Your ref
19/01788/AS

Proposal: a) Outline application for the development of up to 250 residential dwellings (40% affordable) including the creation of access points from Appledore Road (all modes) and Woodchurch Road (pedestrian and cycle only), and creation of a network of roads, footways, and cycleways through the site. Provision of open space including children's play areas, community orchards, sustainable urban drainage systems, landscape buffers and green links all on 12.35 ha of the site. (Matters for approval: Access) b) Full planning permission for the change of land use from agricultural land to land to be used as a country park (8.66 ha), and land to be used as formal sports pitches (3.33 ha), together with pavilion to serve the proposal and the surrounding area. Including accesses, ancillary parking, pathways, sustainable urban drainage systems and associated landscaping.

Site: 19/01788/AS: - Land between Woodchurch Road and, Appledore Road, Tenterden, Kent, TN30 7AY.

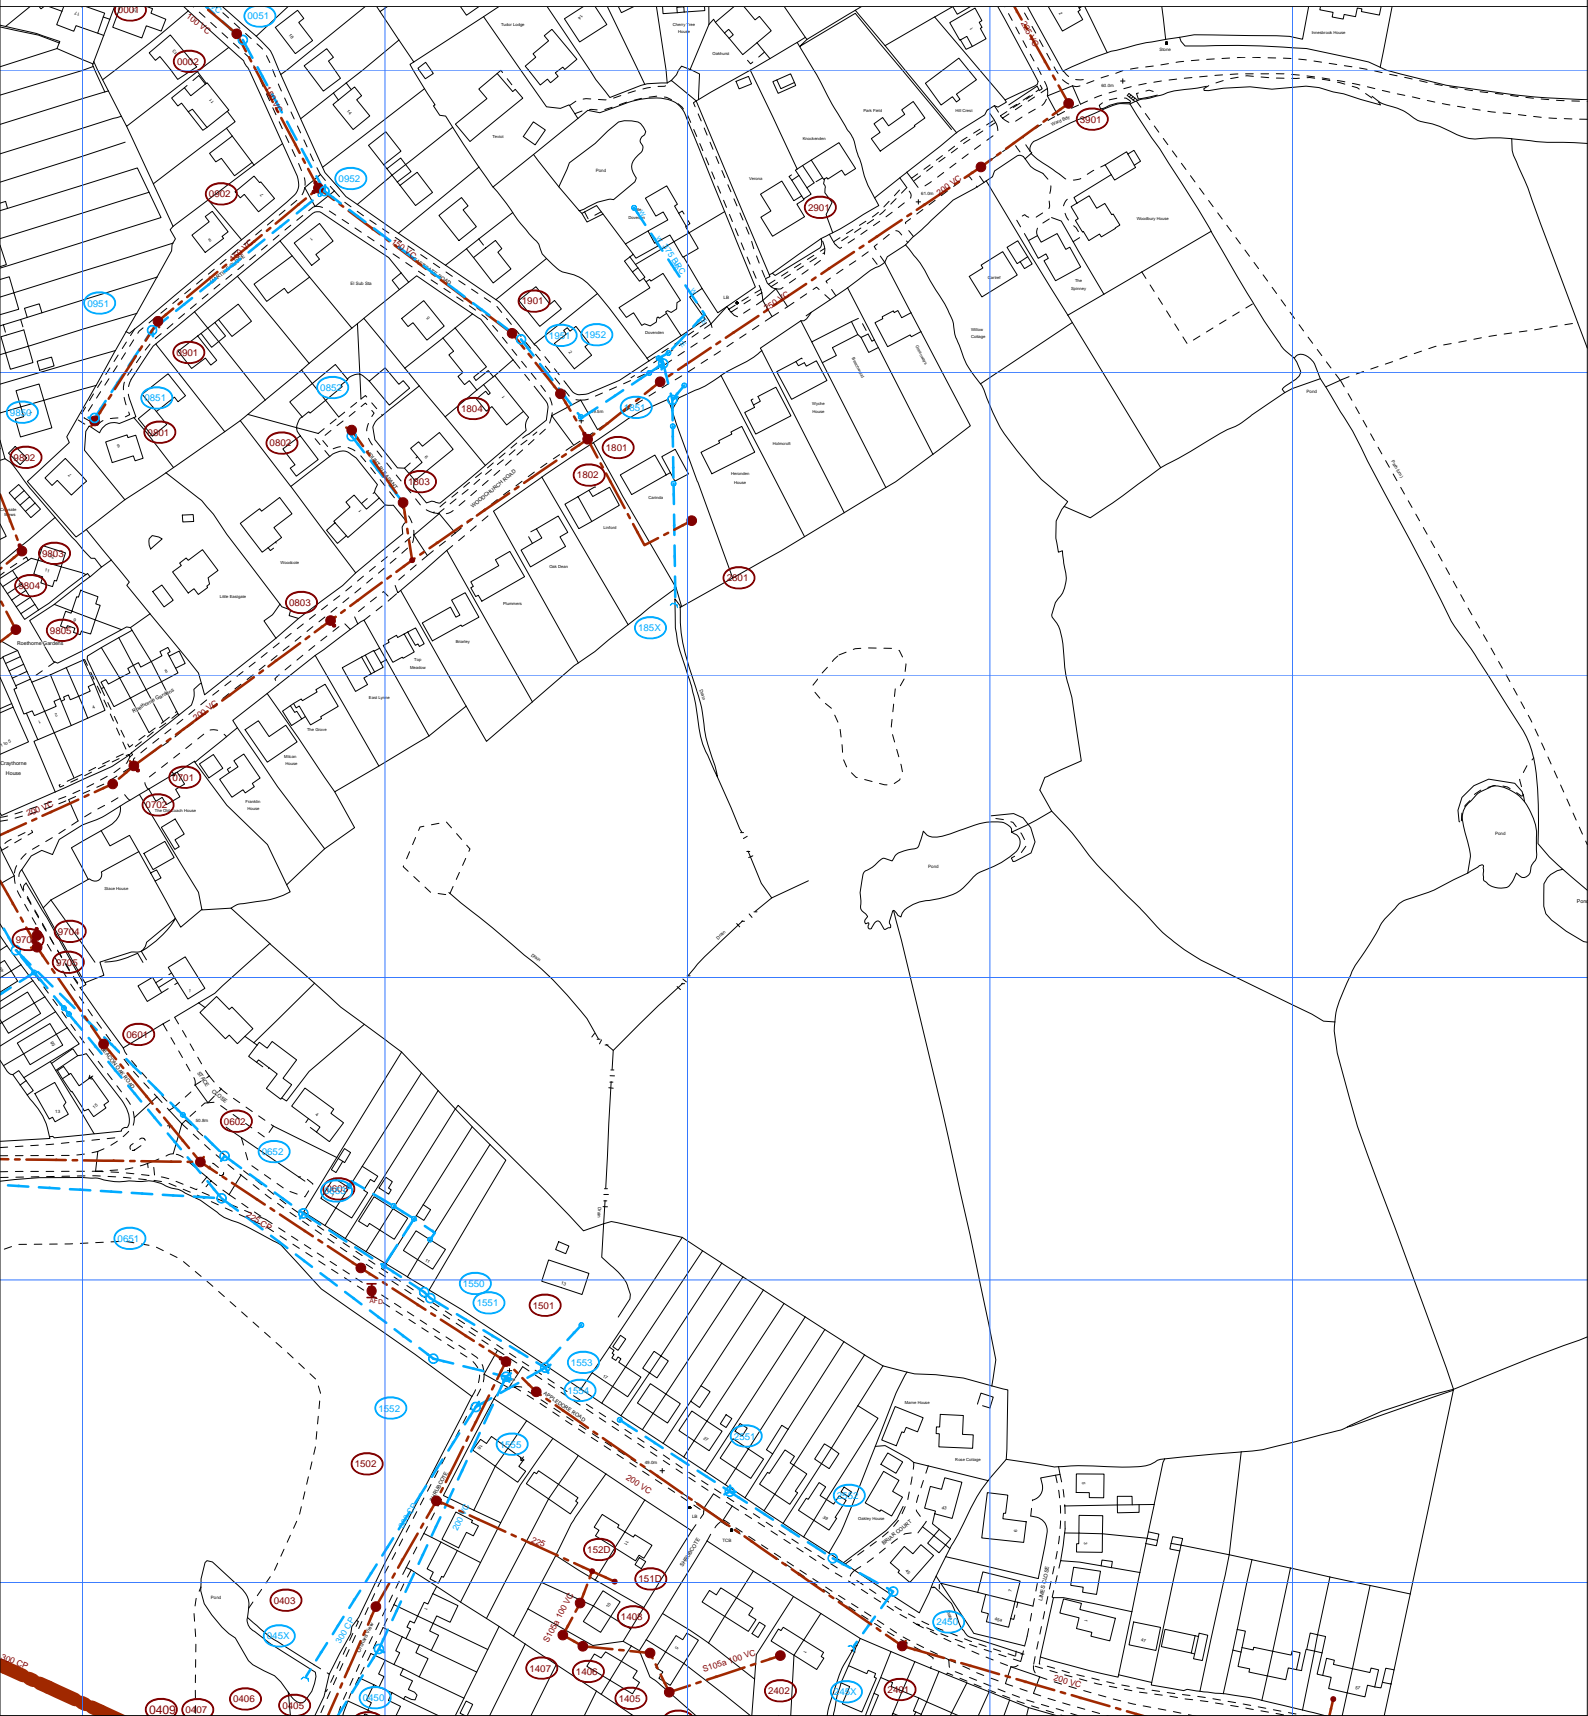
Please find attached a plan of the sewer records showing the approximate position of a public surface water sewer within the site. The exact position of the public sewers must be determined on site by the applicant.

- No development or new tree planting should be located within 3 metres on either side of the external edge of the public sewer.
- All existing infrastructure should be protected during the course of construction works.
- No new soakaways should be located within 5 metres of a public sewer.
